Program Layout and Design

Structural Review

Exterior Elevation Notes: Emery Grover Building, Needham, MA

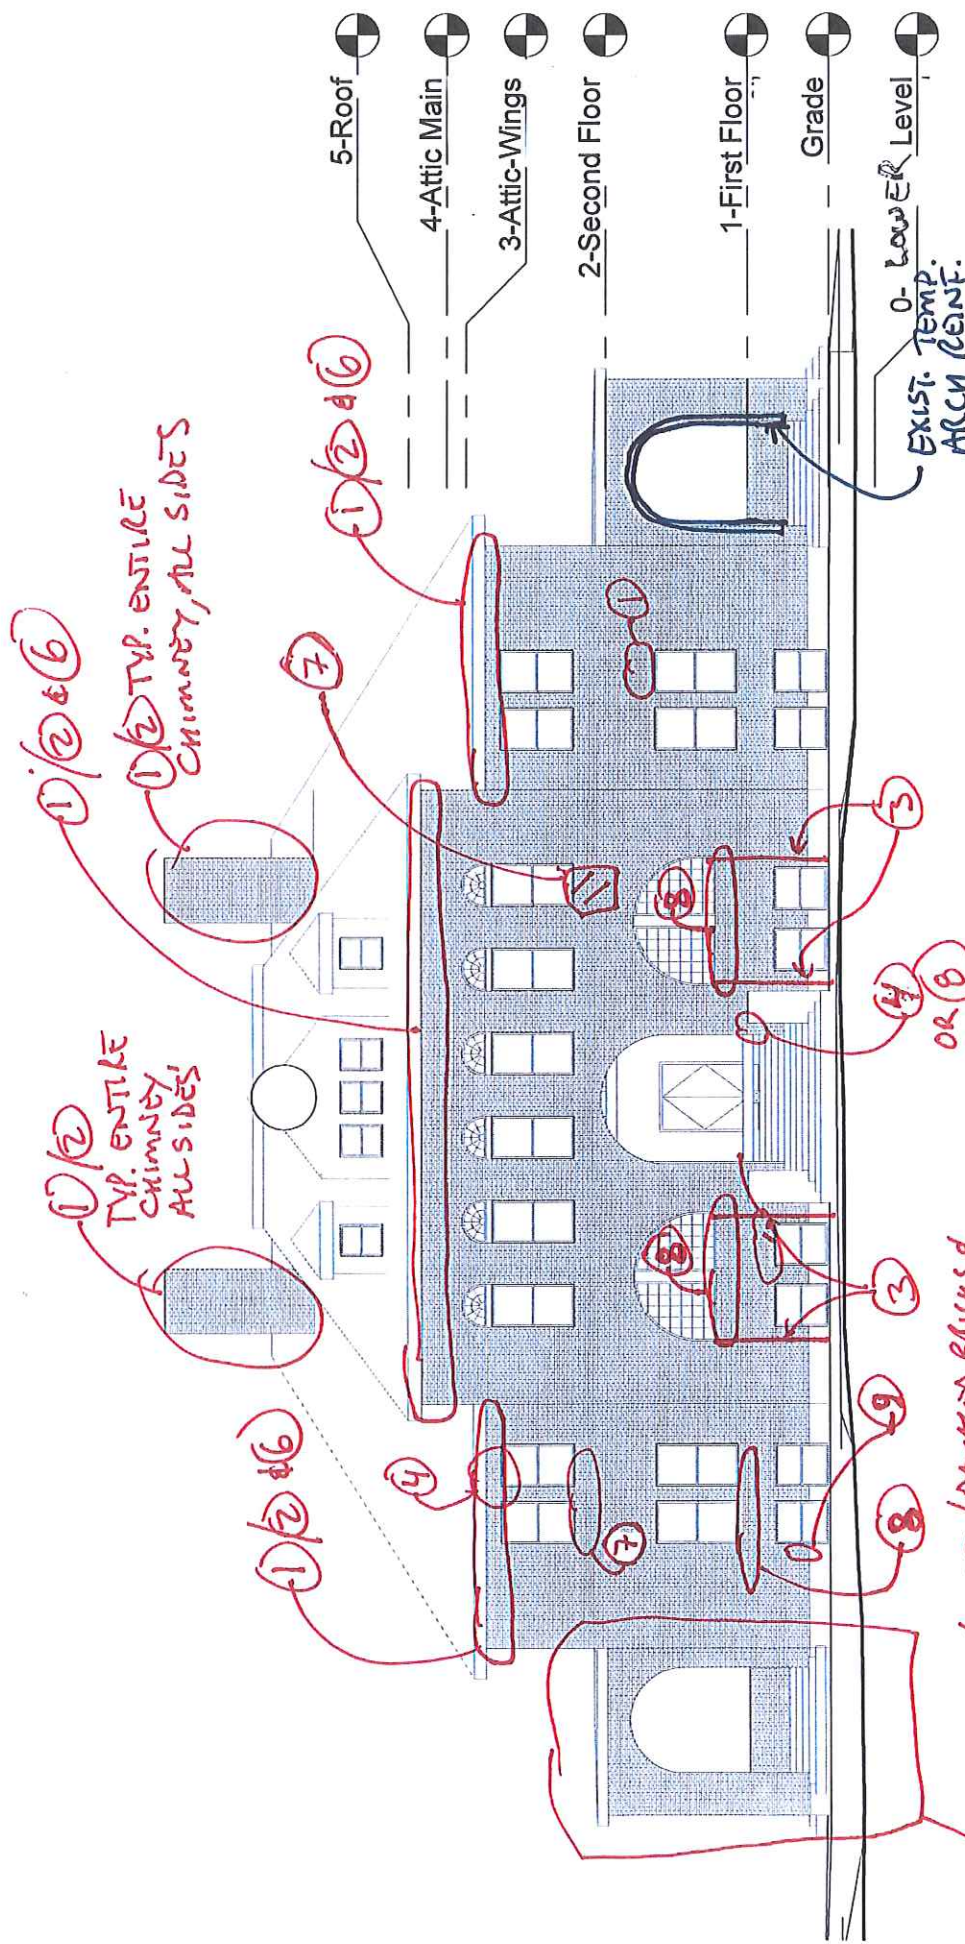
ALL ELEVATIONS: Investigate existing connection of veneer to backup. Smaller dimensions of veneer brick, combined with likely larger brick dimensions for backup brick, likely resulted in infrequent connection between veneer and backup. Assume pinning of veneer to backup will be required.

- ① Repoint.
- ② Re-set or pin loose or shifted bricks or stone sill.
- ③ Caulk joints.
- ④ Reset, replace, and/or stitch brickwork at cracks or damaged bricks.

- ⑤ Possible localized bow or bulge in wall. Will require further investigation into cause. Assume pinning, brick resetting, and re-detailing of connection of interior framing to exterior wall. A lift inspection should be performed and the masonry sounded out with a hammer.

- ⑥ Further investigation is required to determine whether roof thrust loads or rusting embedded metals are causing brick movement.
- ⑦ Consider flashing under the brick soldier course. Reset bricks. (Water is soaking into joints, combined with no brick weight above this level at windows but brick weight from above on adjacent bricks, causing bricks at this location to bow upward).

- ⑧ Pull bricks out and perform a deep re-packing and resetting of bricks. (Issue with brick that readily absorbs water and swells, in combination with a lack of window drip, in contact with stone sill that does not readily absorb water).

- ⑨ Mortar repair cracks. (Issue of brick moisture growth/swelling alongside a stone foundation that does not expand, leading to friction in the joint between the two differing materials).

NORTH ELEVATION

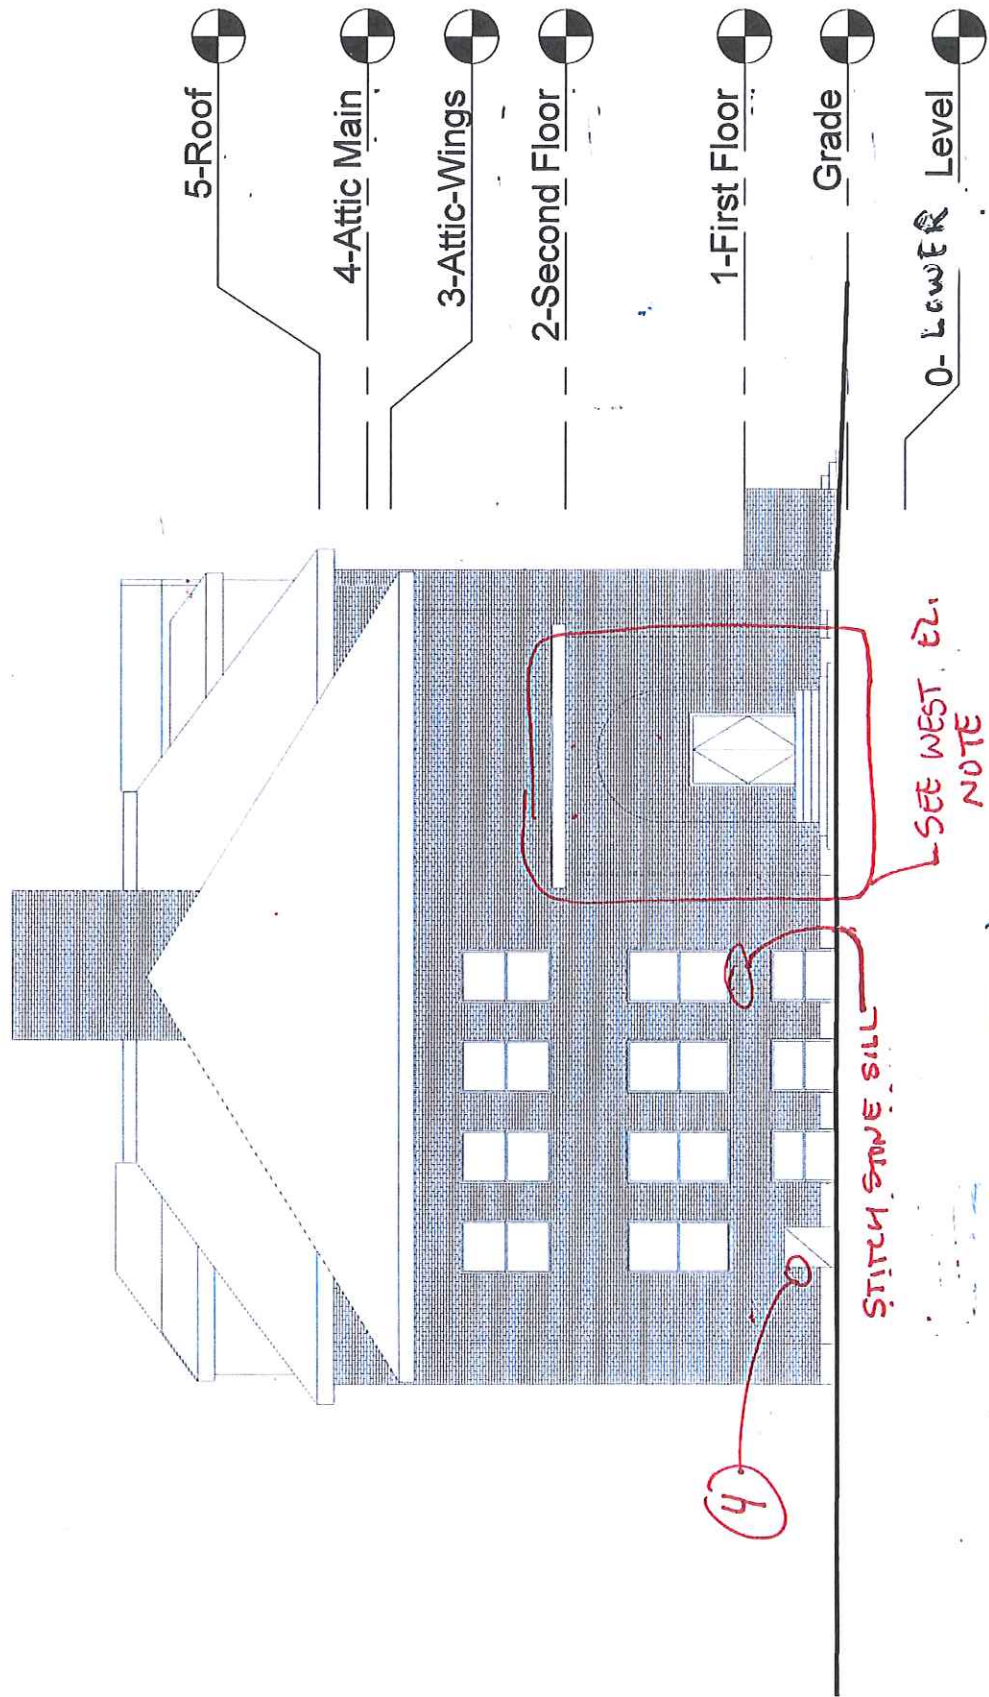
At the south portico, existing steel reinforcing of the 3 arches was observed. A previous engineer's report noted the need for temporary reinforcing of the arches. Our elevation markups note using similar reinforcing at the north

portico, which is exhibiting serious cracks in the arch. If the steel reinforcing at the south portico was intended to be temporary, then a new reinforcing scheme will need to be developed for both porticos. Assume extensive brick re-setting and repointing at the north portico, along with temporary arch shoring and permanent tension rods at the spring of the arches at all arches in both porticos.
